R44 SERVICE BULLETIN SB-104
(supersedes R44 SB-98B)

SUBJECT: Air/Oil Separator Hose

EFFECTIVITY: R44 Helicopters S/N 2566 thru 2607 except 2600. R44 II Helicopters S/N 14284 thru 14384 except 14381 and 14382. R44 Cadet Helicopters S/N 30044 thru 30065 except 30047 and 30061. Also helicopters retrofitted with air/oil separators.

FIGURE 1

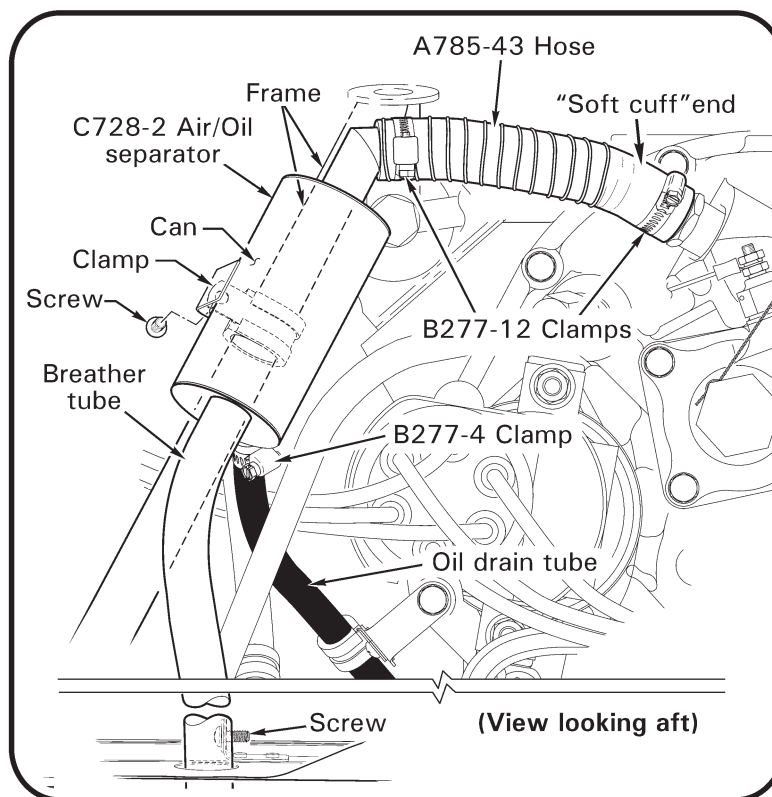
BACKGROUND: RHC received a report of a kinked A729-75 hose, installed between the engine and C728-2 air/oil separator assembly. The kinked hose caused the crankcase to vent through the separator drain back tube resulting in loss of engine oil. R44 SB-98B required a spring to be inserted inside the hose to prevent kinking. However, RHC has found that the hose is still susceptible to kinking. This bulletin requires replacing the A729-75 hose & spring with an A785-43 wire-reinforced hose.

1. Refer to Figure 1. For each affected helicopter, obtain one A785-43 crankcase breather hose, available from RHC Customer Service.
2. Remove engine RH cowling. R44 IIs only: Remove air box assembly per R44 Maintenance Manual (MM) § 6.470.
3. Loosen B277-4 clamp and disconnect black oil drain tube from air/oil separator's can.
4. Loosen screw securing separator's breather tube.
5. Remove screw securing air/oil separator's can-to-frame clamp.
6. Loosen B277-12 clamps and remove A729-75 hose and D774-20 spring; retain clamps and discard hose and spring.

7. Install new A785-43 hose with soft cuff (portion without wire) over engine fitting; secure hose with retained clamps.
